Westinghouse Electric Company
Nuclear Power Plants
P.O. Box 355
Pittsburgh, Pennsylvania 15230-0355
USA

SUBJECT: Transmittal of Responses to AP1000 DSER Open Items

DCP/NRC1617
Docket No. 52-006

SUBJECT: Transmittal of Westinghouse Proprietary Class 2 Documents Related to
AP1000 Design Certification Review Draft Safety Evaluation Report (DSER)
Open Item Response

Figure 3

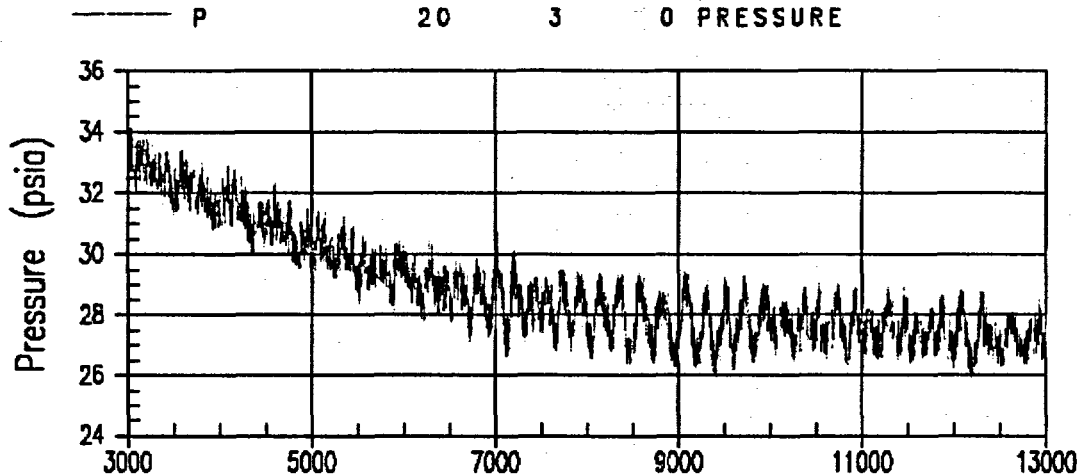
The time scale of the plots herein is adjusted to reflect DEDVI break transient time. Figure 3 shows the upper plenum pressure. The pressure decreases from its initial value to reach a quasi steady state value of 28 psia at about 7000 seconds.

Figure 4

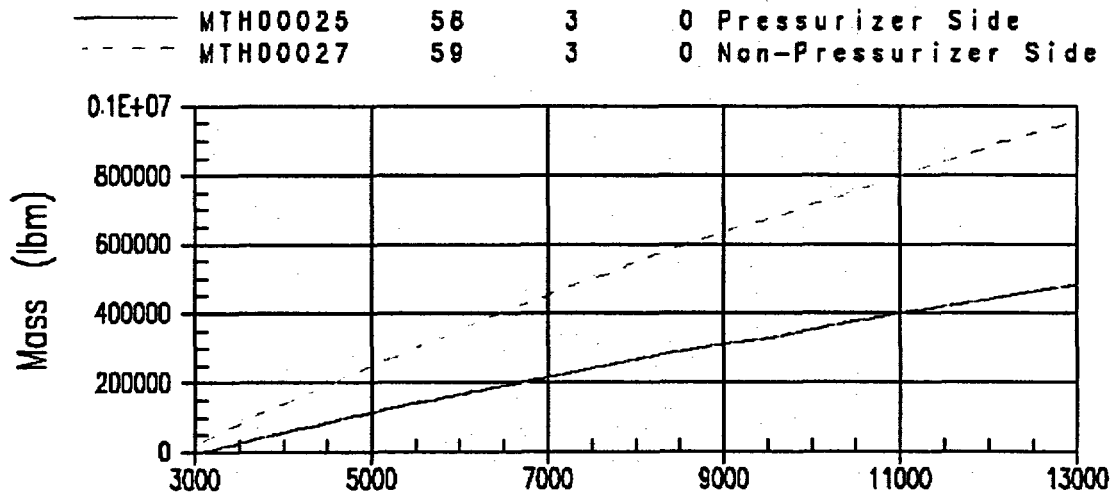
The next figures 4 and 5 show the ADS4 integrated flows and the integrated flows from the DVI nozzles:

Figure 6

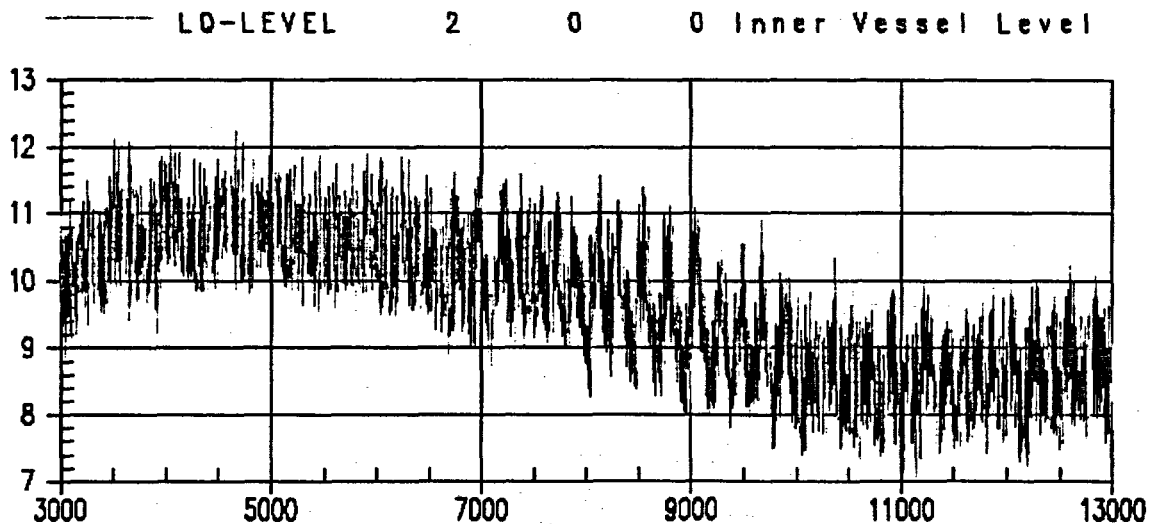
The inner vessel collapsed liquid level as well as the core region only collapsed liquid level are shown in Figures 6 and 7:

Figure 8

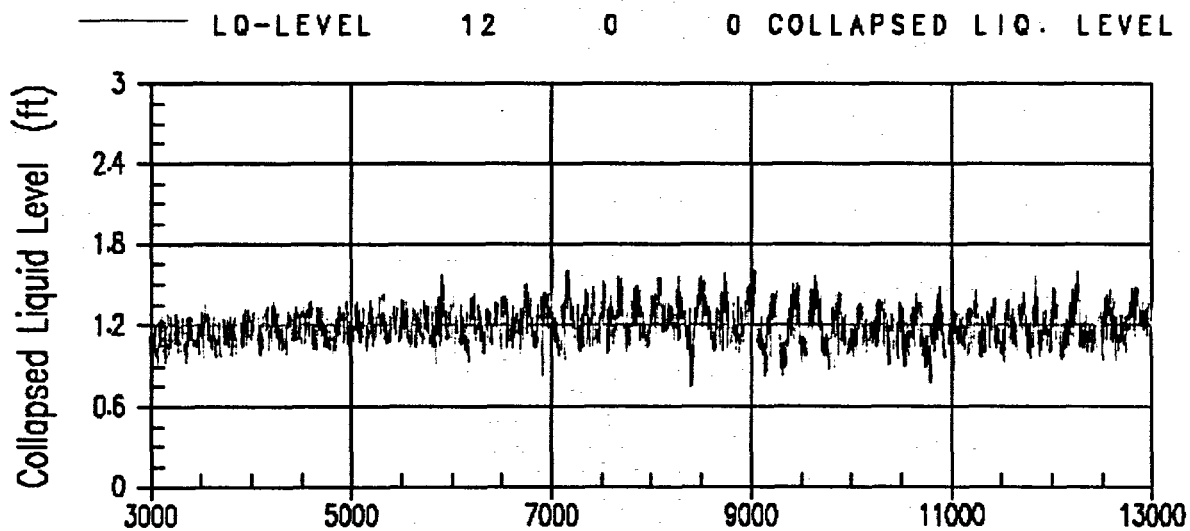
Figure 8 shows that the mixture level is located in proximity of the hot leg centerline.

Figure 9

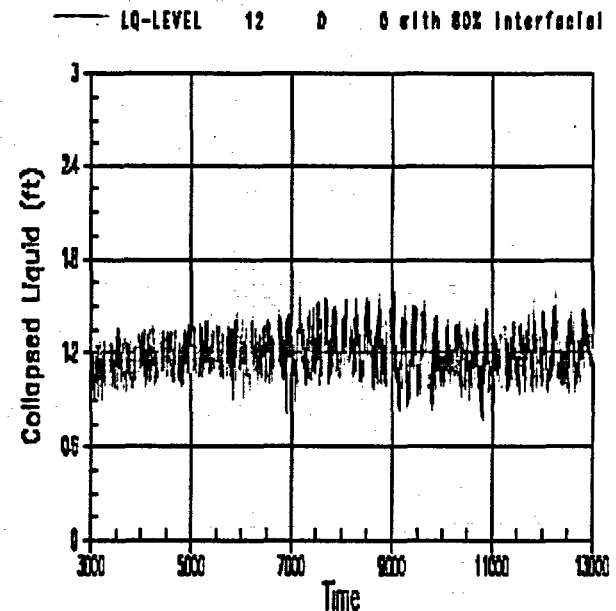
It is worth to note that the LTC case was analyzed with both nominal Interfacial drag model and with 20% reduced interfacial drag model and it was observed that the hot leg levels from these calculations were nearly identical as shown in Figure 9.

This result is an indication that once the mixture level is located above the top of the core and well into the upper plenum, the interfacial drag model or core swell model has a very small effect on the overall system behavior.

Figure 10

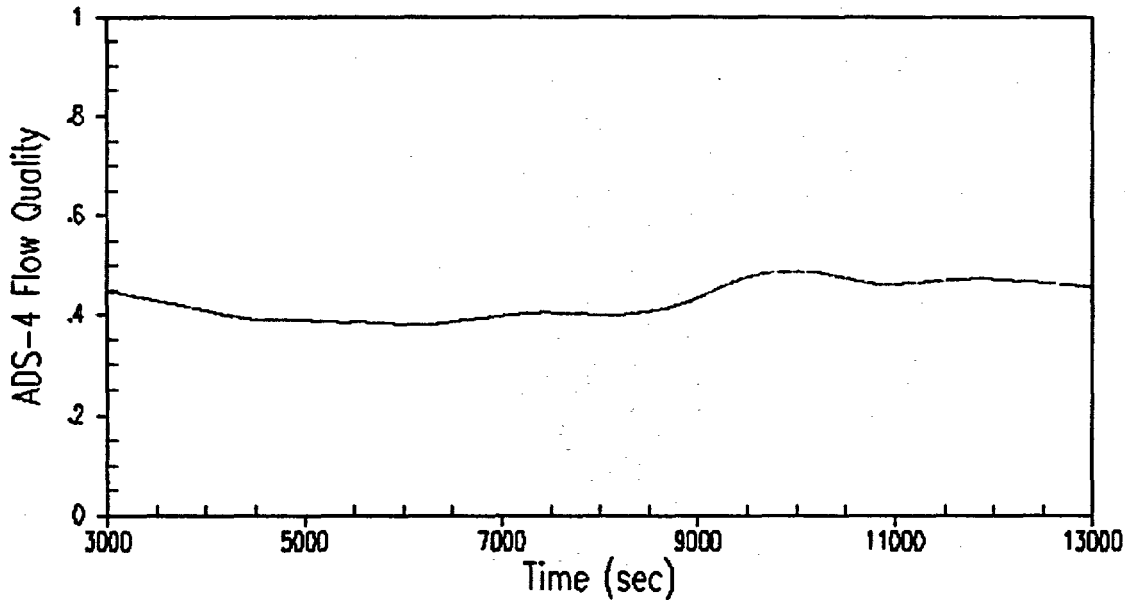
The liquid supply (core inlet liquid flow) is always sufficient to remove the decay heat. Additional liquid is stored in the upper plenum and discharged by the ADS-4. Figure 10 shows that the ADS-4 average exit quality float around 50% during the LTC transient.

Figure 11

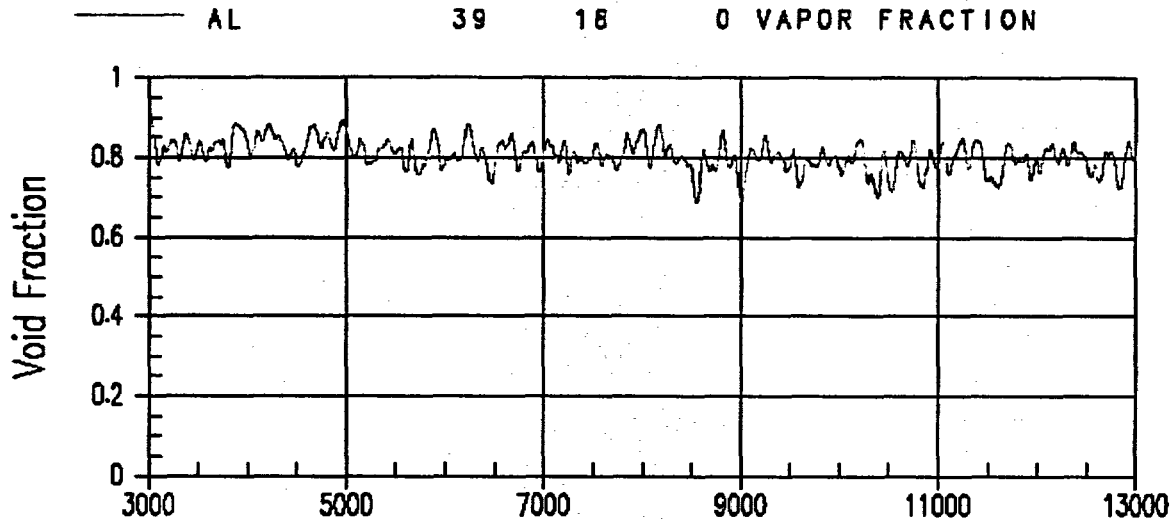
The predicted void fraction at the top of the core hot assembly is approximately 0.8 during the transient (Figure 11) which is another indication that sufficient liquid is provided at the top of the core preventing core heat-up from occurring.

Figure 12

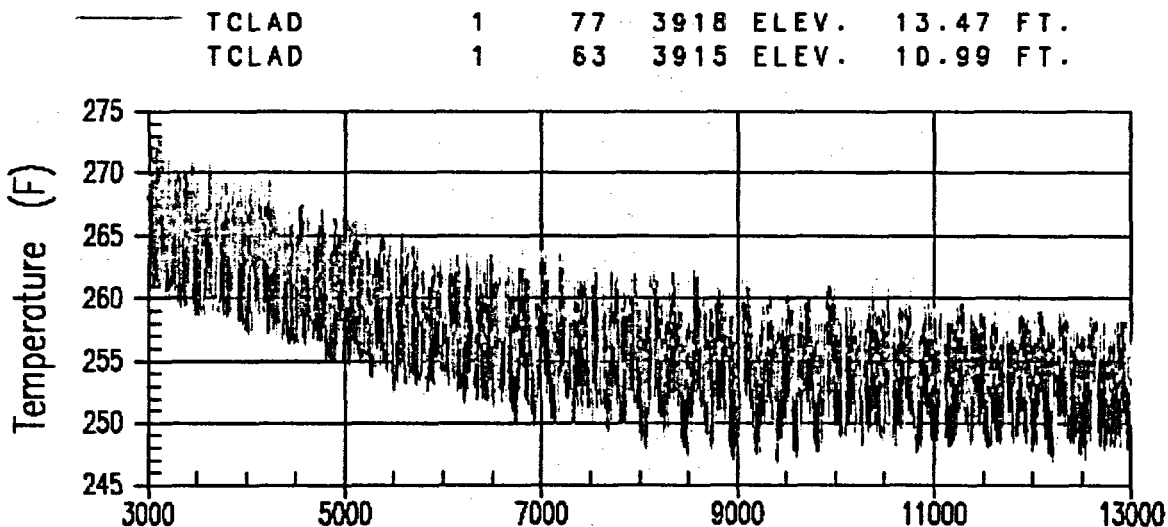
Figure 12 shows that the clad temperature in the top region of the core is always close to the saturation temperature and no heat-up excursion is predicted to occur.

Figure 15.6.5.4C-2

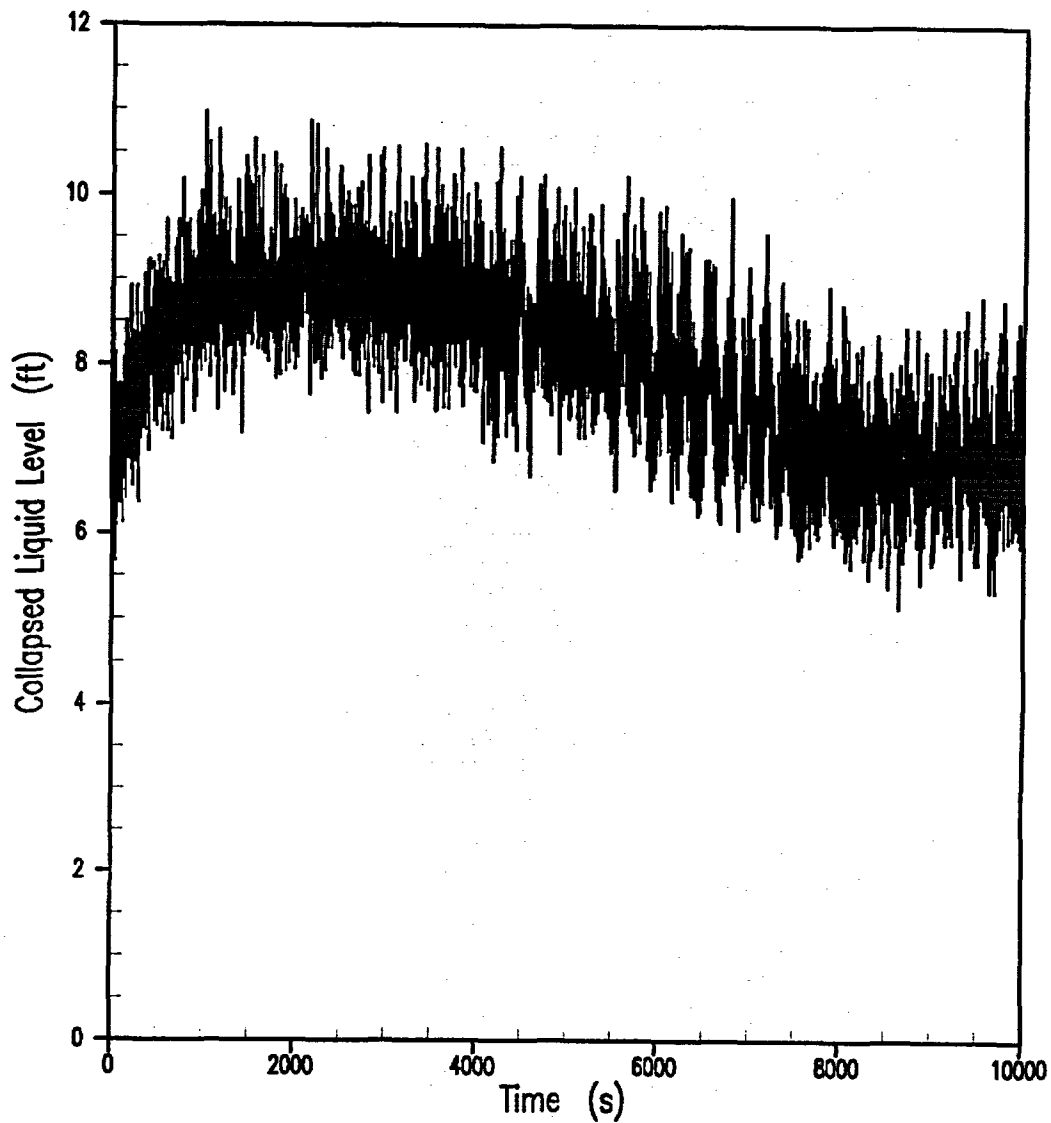
Boiling in the core produces steam and a two-phase mixture, which flows into the upper plenum. The core is 14 feet high, and the core average collapsed liquid level (Figure 15.6.5.4C-2) is about 7.7 feet at shown from the start of long-term cooling. The boiling process causes a variable rate of steam production and resulting pressure changes, which in turn causes oscillations in the liquid flow rate at the bottom of the core and also variations in the core collapsed level and the flow rates of liquid and vapor out of the top of the core. In the WCOBRA/TRAC noding, the core is divided into two axial levels, each of which is 7 feet high both axially and radially as described in Reference 24. The void fractions in the top two levels cells of the hot assembly are shown as Figures 15.6.5.4C-3 and -4. The core void fraction is low for the bottom cell and has a mean void fraction less than 0.1 for the entire long-term cooling transient. The average void fraction of these upper core cells is about exceeds 0.8 during at the start of long-term cooling, during IRWST injection, and decreases as the decay heat decreases, and levels out into the containment recirculation period, that begins at 6700 seconds on the figures. There is a continuous flow of two-phase fluid into the hot legs, and mainly vapor flow toward the ADS Stage 4 valve occurs at the top of the pipe. The collapsed liquid level in the hot leg varies between +0.9 feet to 1.75 feet (Figure 15.6.5.4C-5). The hot legs on average are more than 50-percent full. Vapor and liquid flows at the top of the core are shown in Figures 15.6.5.4C-6 and 15.6.5.4C-7, the upper plenum collapsed liquid level in Figure 15.6.5.4C-8. Figures 15.6.5.4C-9 and 15.6.5.4C-10 are ADS stage 4 mass flowrates.

Figure 15.6.5.4C-11

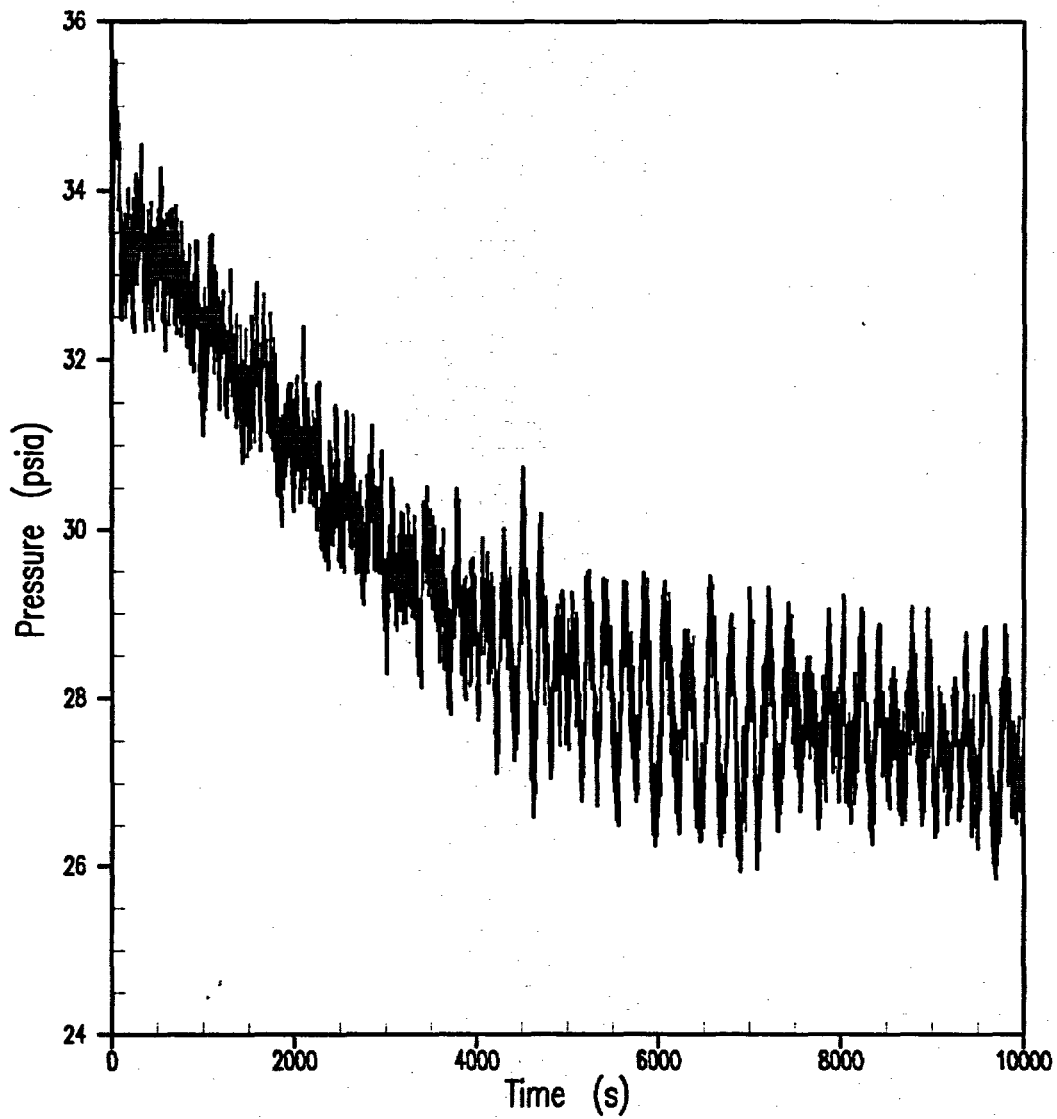
The pressure in the upper plenum is shown in Figure 15.6.5.4C-11. The upper plenum pressure fluctuation that occurs is due to the ADS Stage 4 water discharge. The hot rod PCT at the top of the hot assembly rod follows saturation temperature (Figure 15.6.5.4C-12), which demonstrates that the calculated core collapsed liquid level is adequate to provide enough liquid at the top of the core that no uncover and no cladding temperature excursion occurs. A small pressure drop is

Figure 15.6.5.4C-12

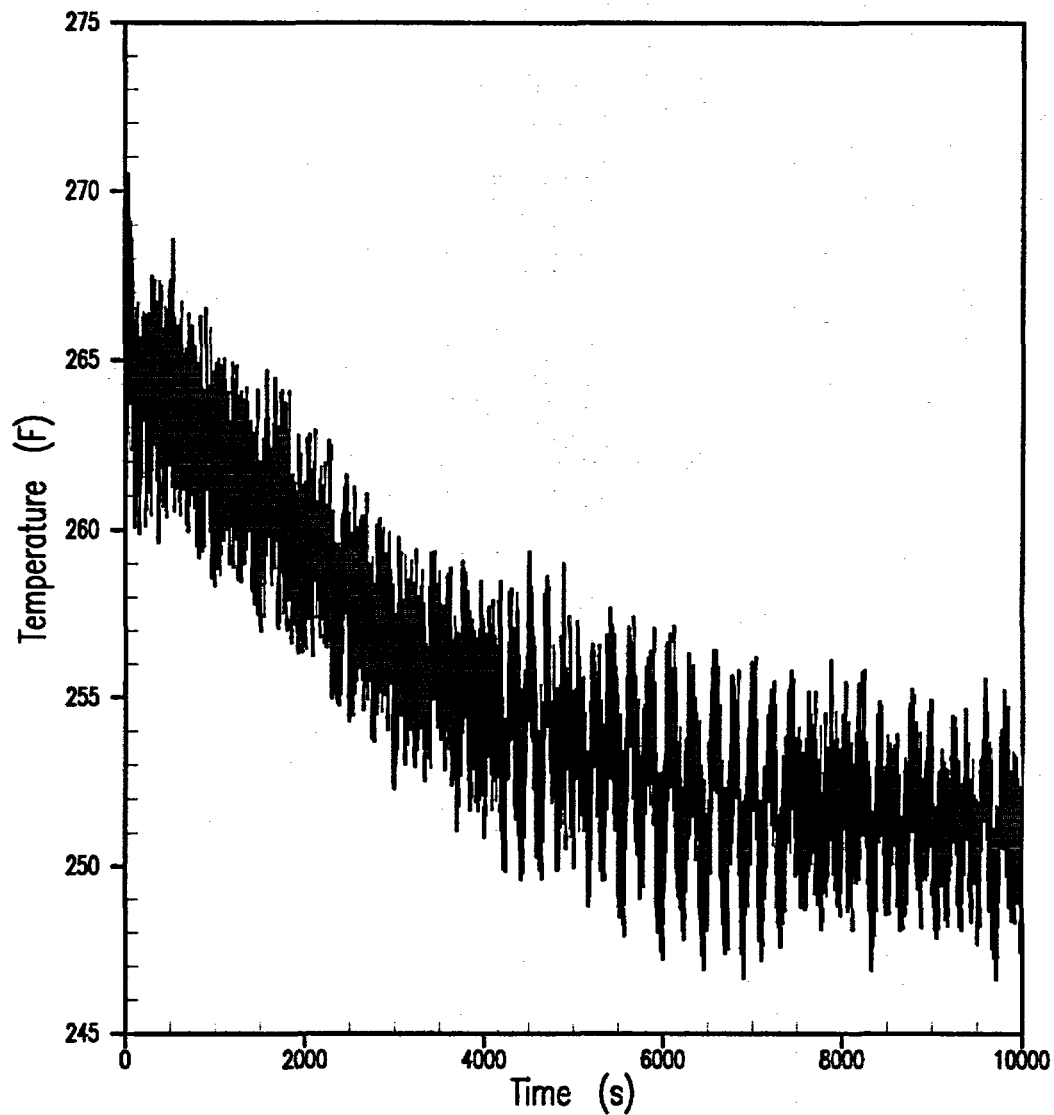
~~PCT of the Hot Rod~~ Hot Rod Cladding Temperature Near Top of Core
(DEDVI Case)
